TECHNICAL BULLETIN

OVERVIEW:

It has recently come to our attention that a Nordyne product change could affect the function of auxiliary heat on air handlers purchased between August 3, 2015 and December 1, 2015.

Illustration 1 - Example of incorrect wiring

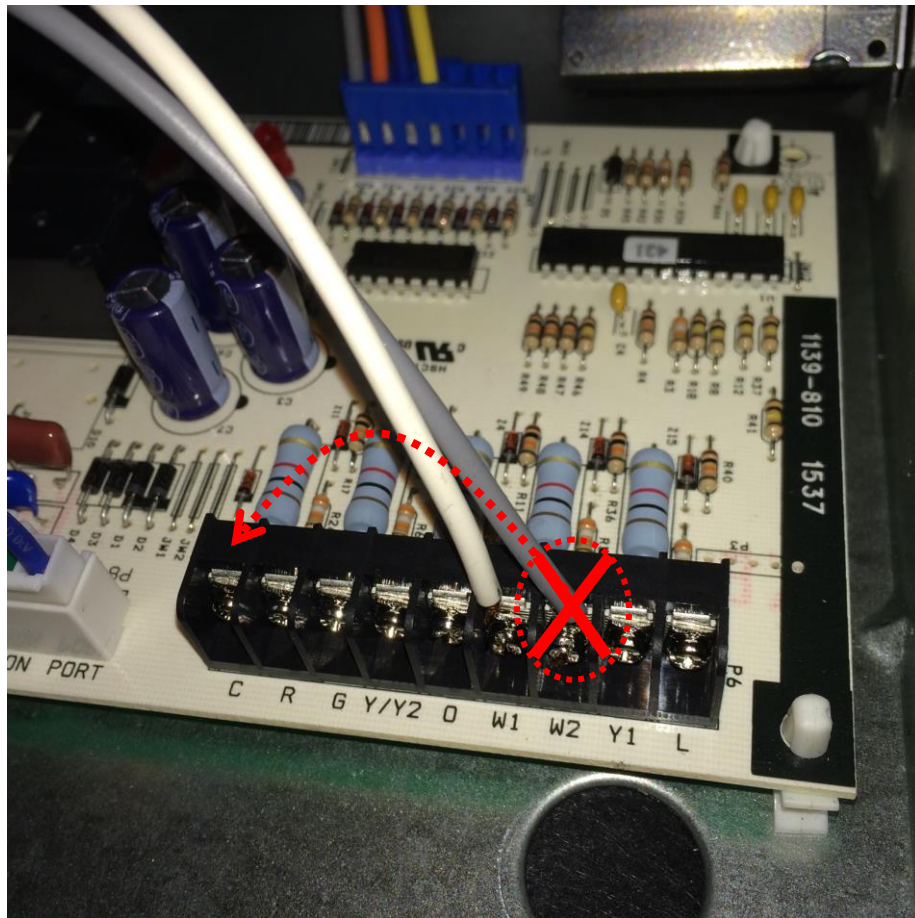
→ **The Grey wire running from the Electric Strip heat to the Air Handler control board should be wired on Common (C terminal) and not on terminal W2.**

Illustration 2 - Example of correct wiring

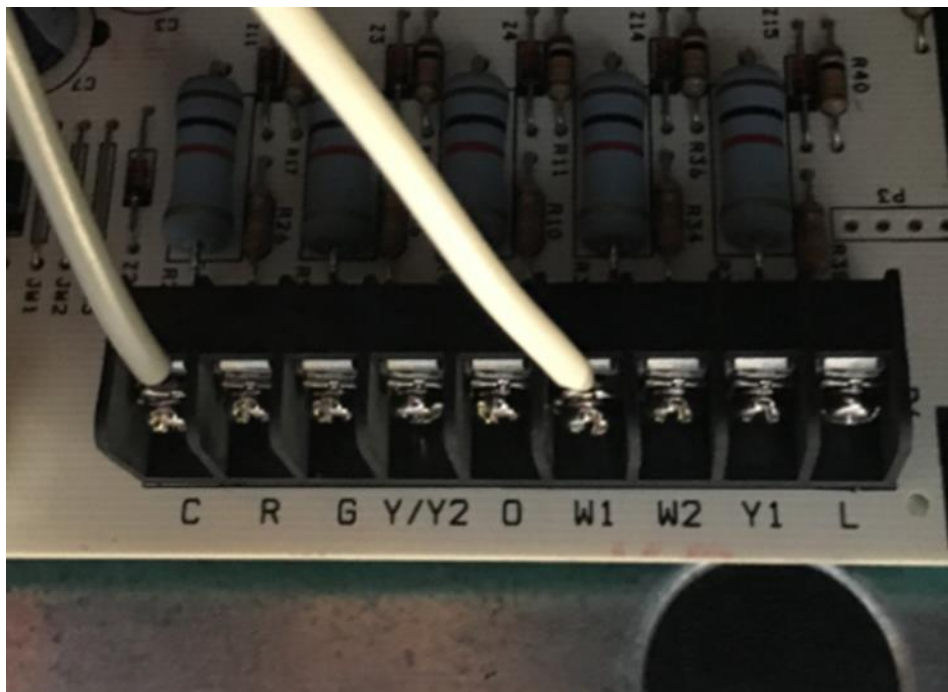
Illustration 2: Example of correct wiring
